Municipal Class Environmental Assessment Study: Credit River Erosion Control Project from Dundas St West to Highway 403

Credit River Erosion Control EA & Detailed Design
Dundas Street West to Highway 403

SITE #7 – POTENTIAL PREFERRED ALTERNATIVE

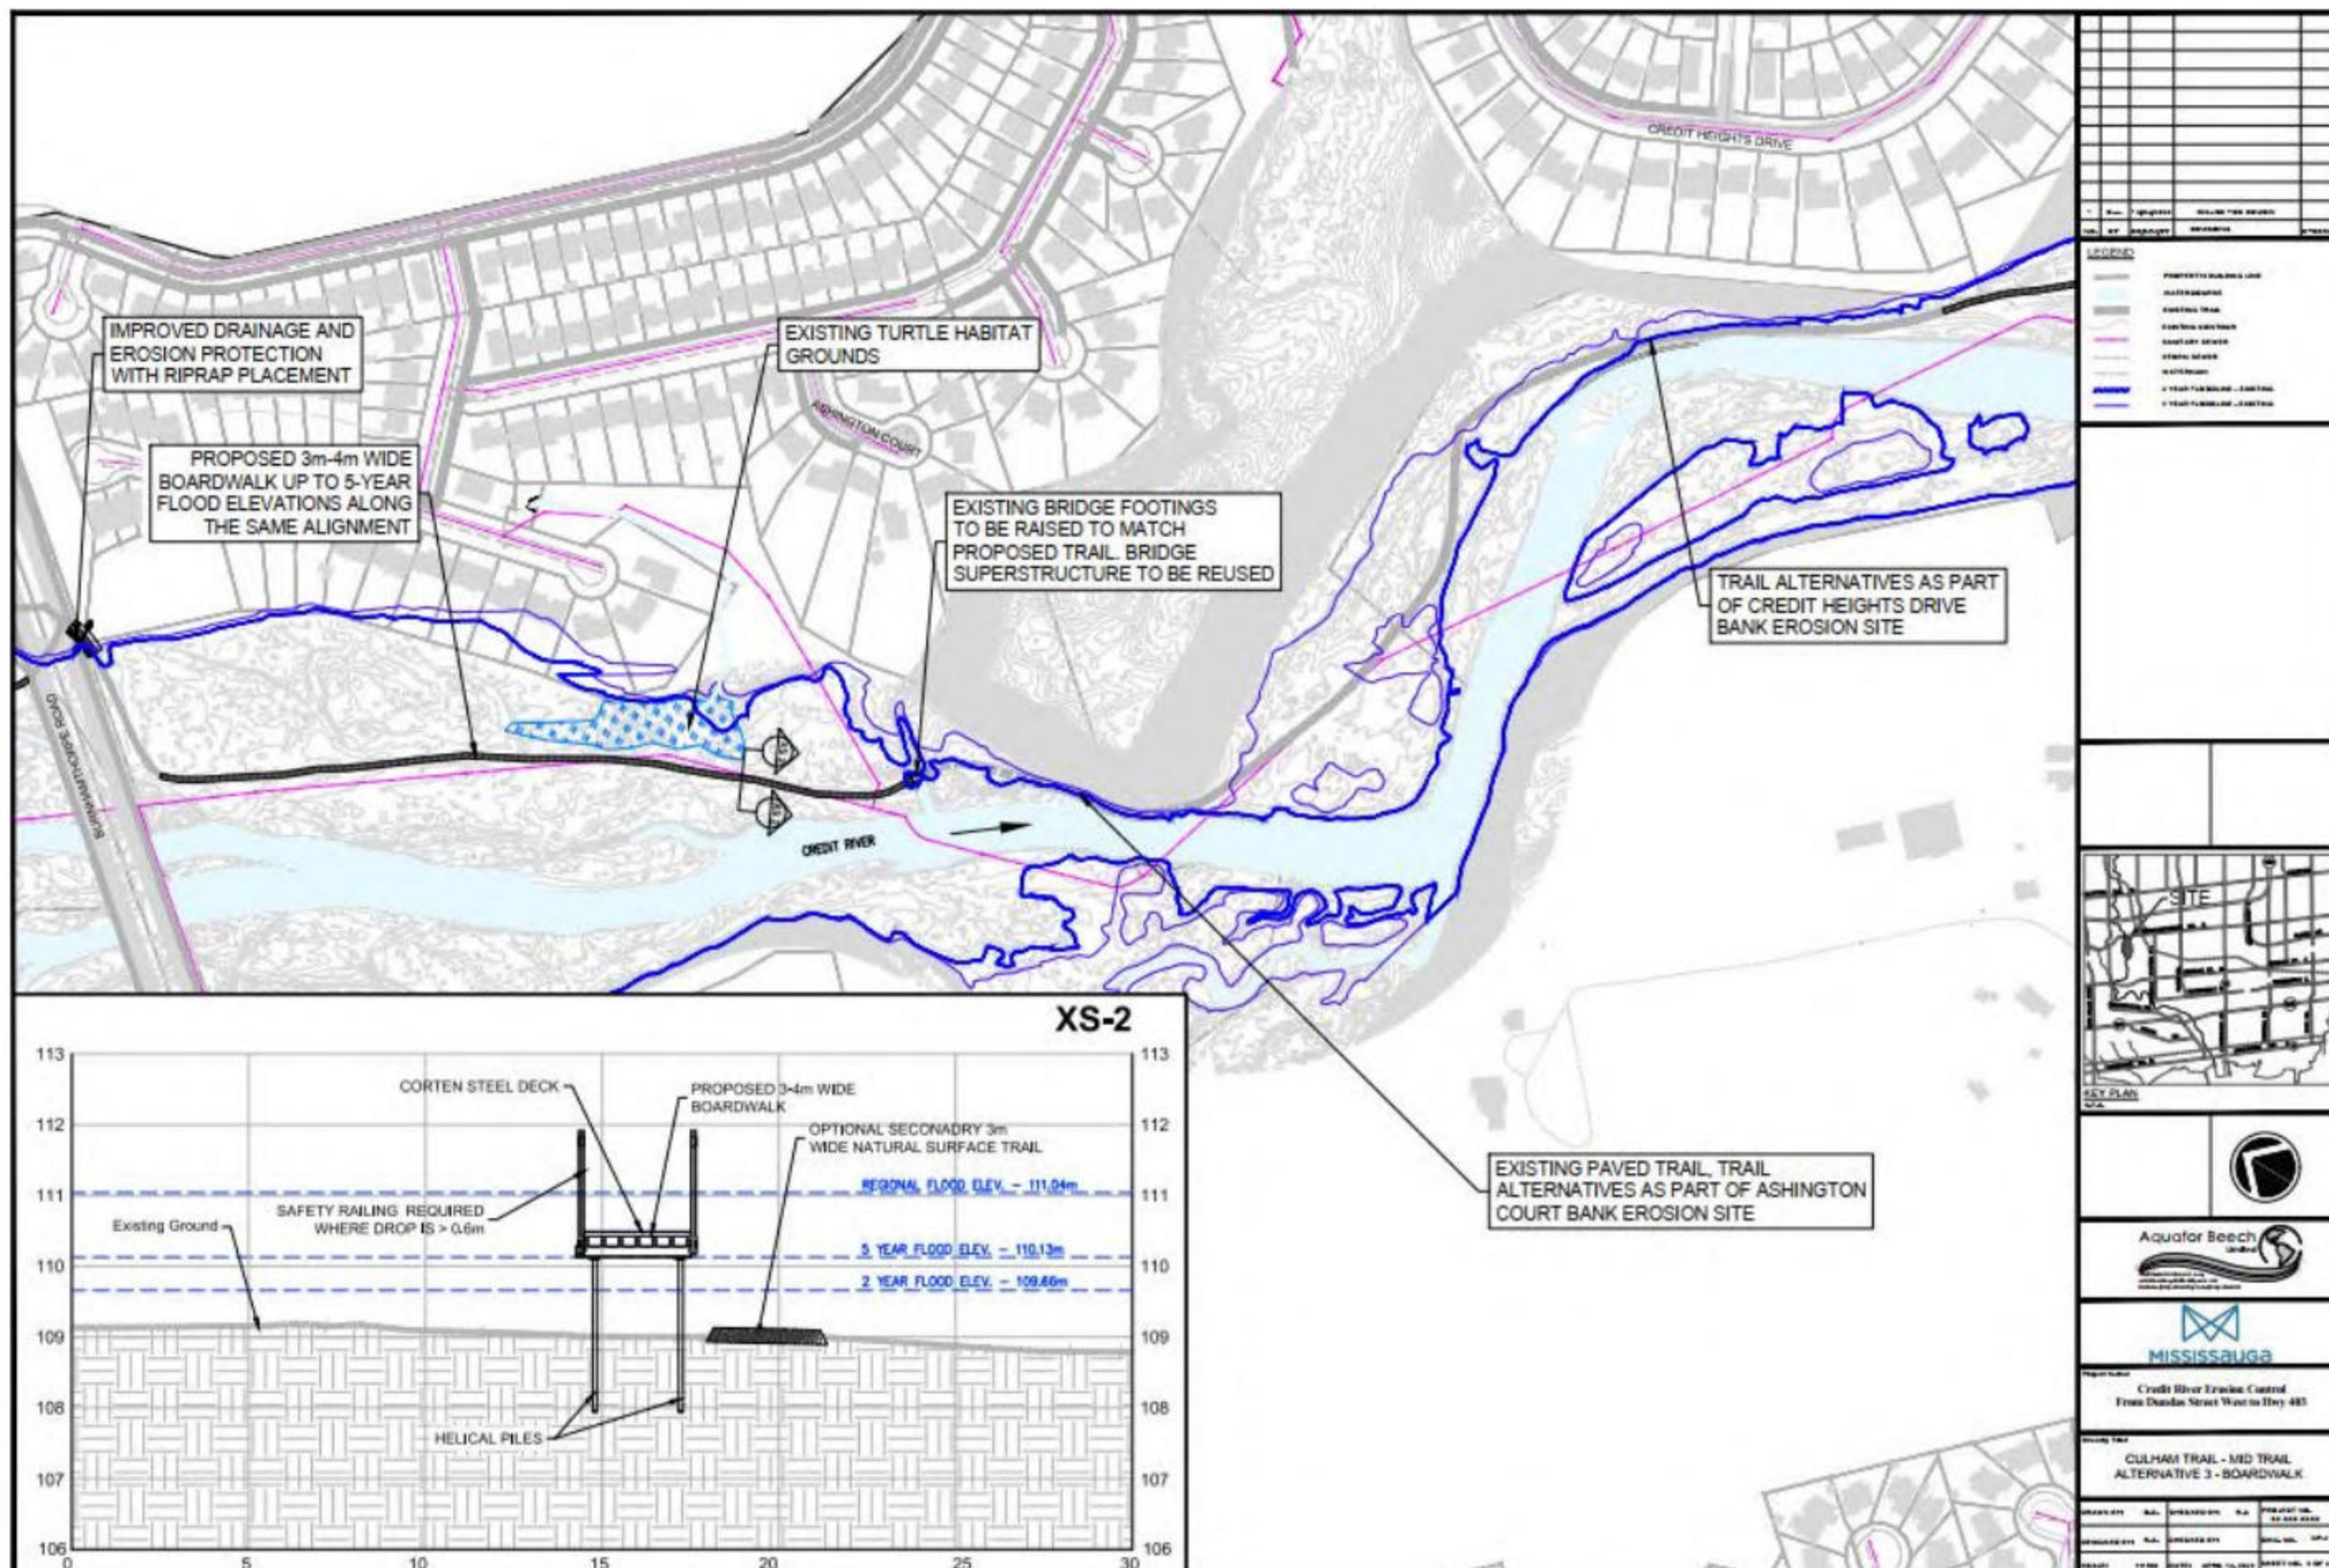
8.	<p>For Drawing 8- Mid Trails, which is adjacent to the turtle pond and breeding habitat:</p> <ul style="list-style-type: none"> a. Remove the optional 3m wide natural surface trail. This is not necessary with a 4m wide boardwalk and will increase temporary and long-term impacts to the Natural Features (vegetation communities and the turtles); b. Ensure that the proposed boardwalk is aligned with the existing trail footprint; c. We support railings along the boardwalk to guide visitors; and d. Would it be possible to incorporate a gate along the boardwalk for City staff access only? 	<p>Comment is noted. Design details such as removal of the optional 3m wide trail and addition of a gate along the boardwalk will be considered during the detailed design process for this site. The proposed boardwalk will be aligned with the existing trail footprint. Support of the railings along the boardwalk has been noted.</p>

SITE #8 – POTENTIAL PREFERRED ALTERNATIVE

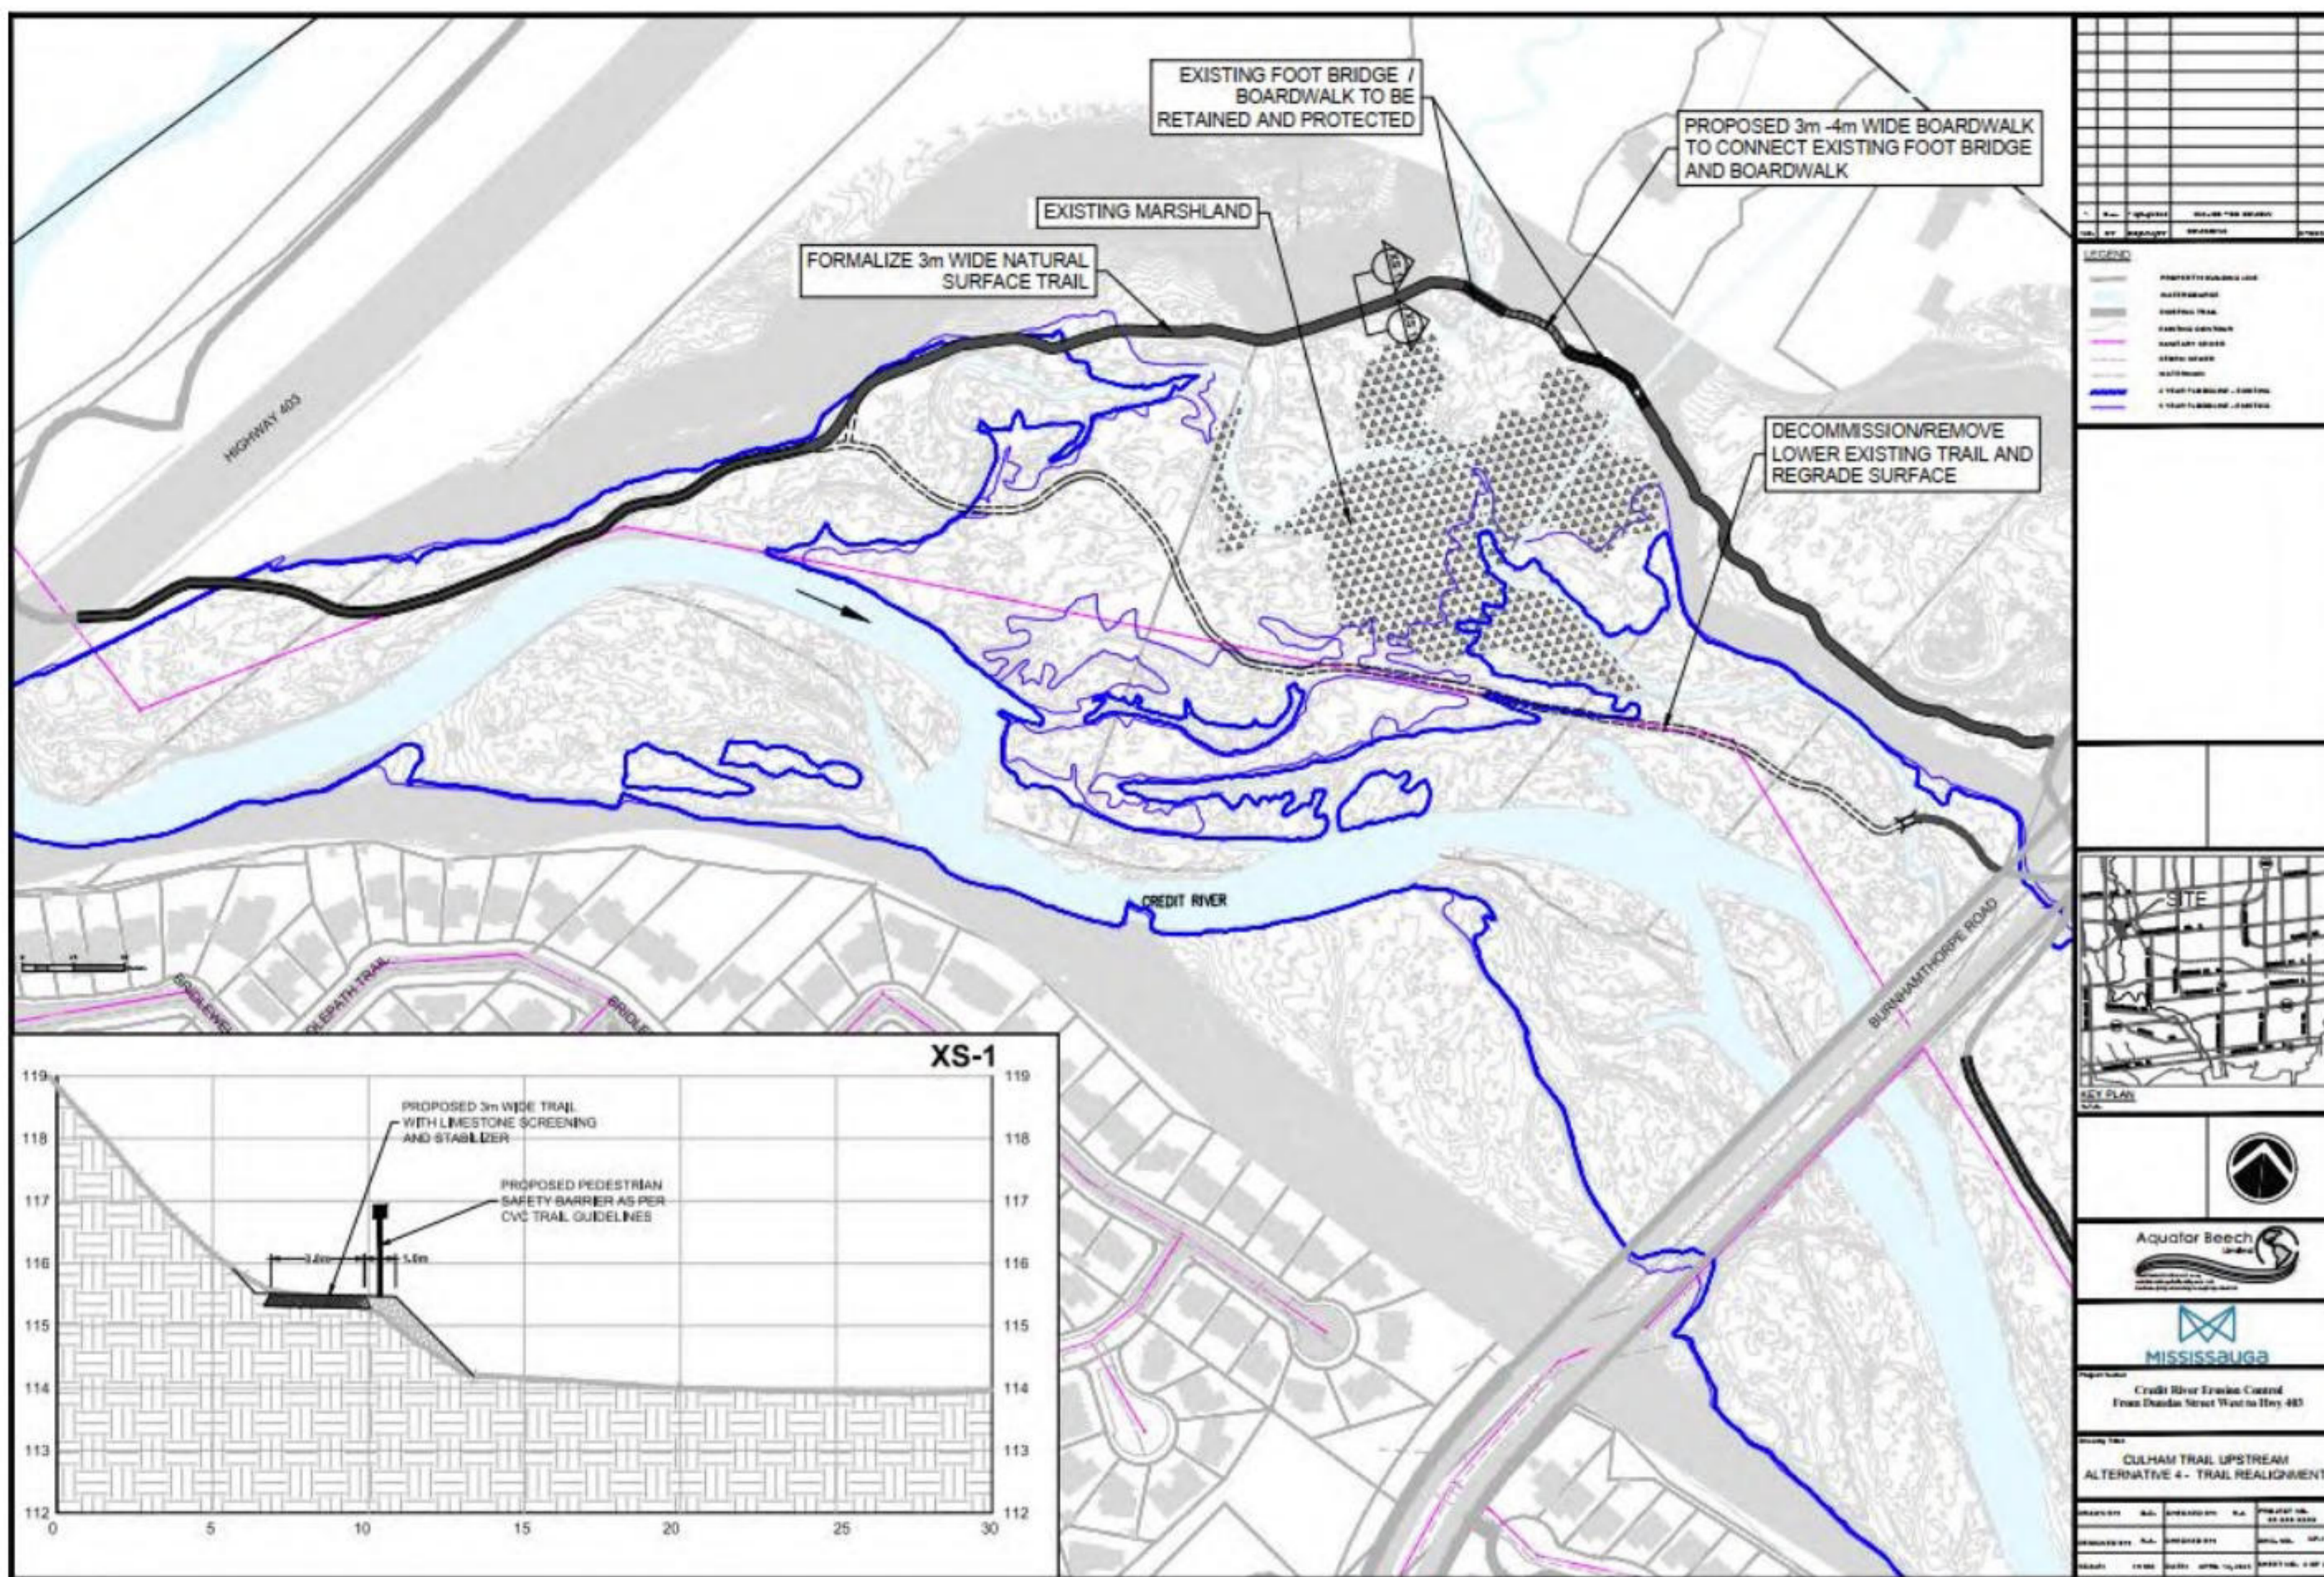
9.	<p>For Drawing 9 – Upstream Trails and following the site visit on Thursday, July 6th with Riverwood and City staff:</p> <ul style="list-style-type: none"> a. In all areas where trail widening is being considered, there will need to be supporting documents and ecological surveys completed; b. Railings and trail delineation designs (natural materials ideal) are encouraged to help guide visitors to stay on official trails and reduce vegetation trampling and ad-hoc trails; c. Forestry supports the decommissioning of the lower Culham Trail segment due to flooding risk and disturbance from washed out gravel. However if this segment is decommissioned then it should be densely naturalized with native tree/shrub plantings and not kept as an informal trail. This would reduce fragmentation within the Natural Feature, increase the floodplains ecological functions, and greatly enhance the City’s Natural Heritage System. Appropriate fencing and/or railings can be installed at each end to visually illustrate to visitors that the old trail segment is closed. Informative signage could be installed on each railing or fence to inform visitors why the trail is closed and show the official trail network. Turtle nesting habitat, 	<p>Ecological surveys will be completed during the detailed design process for this site. A new alternative, Alternative 5, was created in which the primary upper trail through Riverwood will be improved through formalization of the natural surface trail with limestone screenings and safety barriers where warranted. The secondary lower trail will be regraded above the 5-year flood elevation, stone lined swales will be added on both sides, and concrete box cross culverts will be added under the trail in order to reduce flooding risk and minimize required maintenance. This was selected as the preliminary preferred alternative. Avoiding further engineering the Credit River will be considered wherever possible.</p>
